# Memorandum

**Project** DC Major League Baseball Park  
**Client** DCSEC  
**Date Prepared** June 27, 2006  
**Project Number** 05.14017.00  
**File**  
**Total Pages** including this sheet

**Attention** Zoning Commission  
**From** Susan Klumpp – HOK/D&P  
**Regarding** Anacostia RIVERKEEPER response – Zoning Commission Hearing  
**Copies To** Joe Spear – HOK/D&P, Bill Mykins –B&D, Chris Dunlavey – B&D, File

SANDFILTER WITH MODIFIED 1ST CHAMBER FOR WASHDOWN WATER FLOW  
 SCALE: 1/4" = 1'

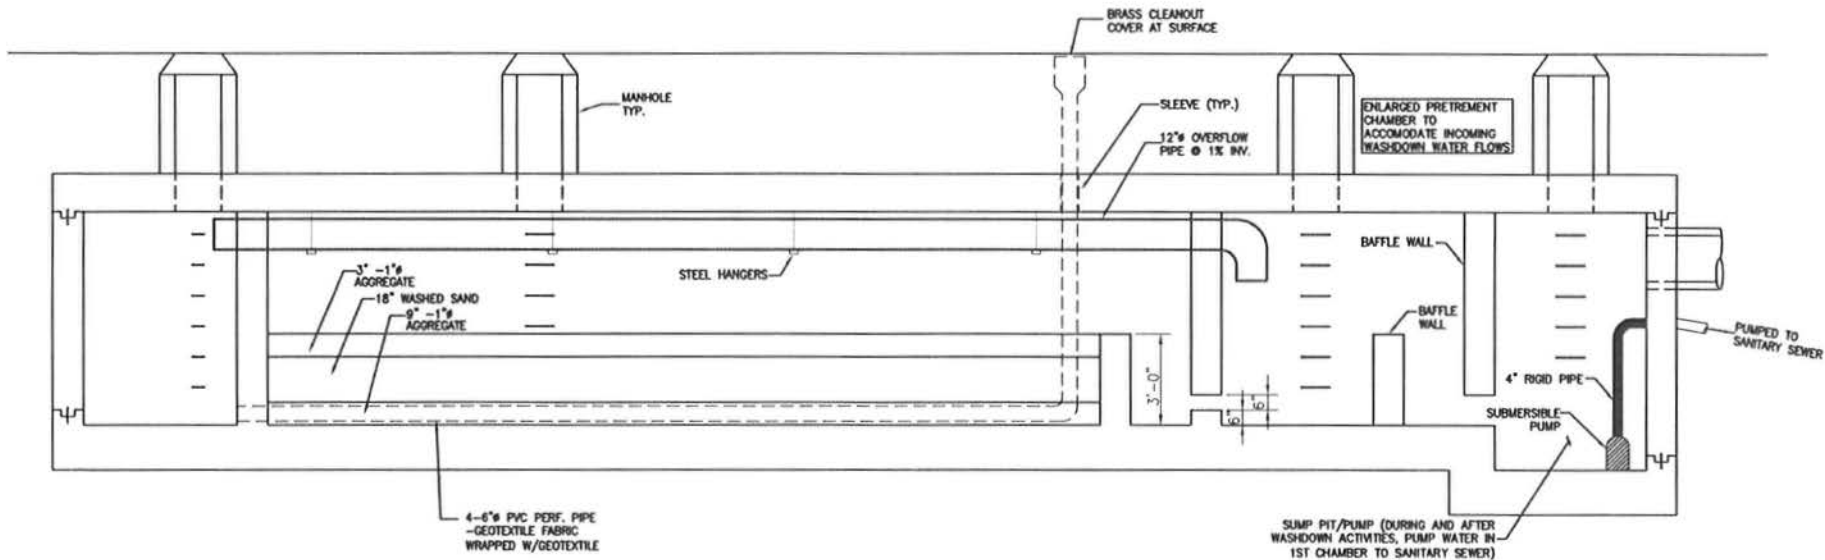
**1A. Building wash-down system (lower and upper bowl drainage):** There is a concern about whether the sand filtering system currently proposed for the storm-water system will be sufficient to handle the pollutants from building wash-down activities. HOK/D&P team has created a "super sand filter" (ref attached sketch) that will allow building wash down water to be captured and collected in (and enlarged/enhanced the first chamber of this structure and pumped at a low flow rate to the sanitary sewer system thereby ensuring that water potentially containing detergents does not reach the Anacostia River.

The balance of storm water collected from the lower and upper bowl systems will be run through debris guards with expanded wire mesh screens over the bowl drains. Area drains in the concourse will have sediment baskets with perforated lids. Water collected will then run through the "super sand filter" chambers for additional removal of particulates prior to being released to the storm water system.
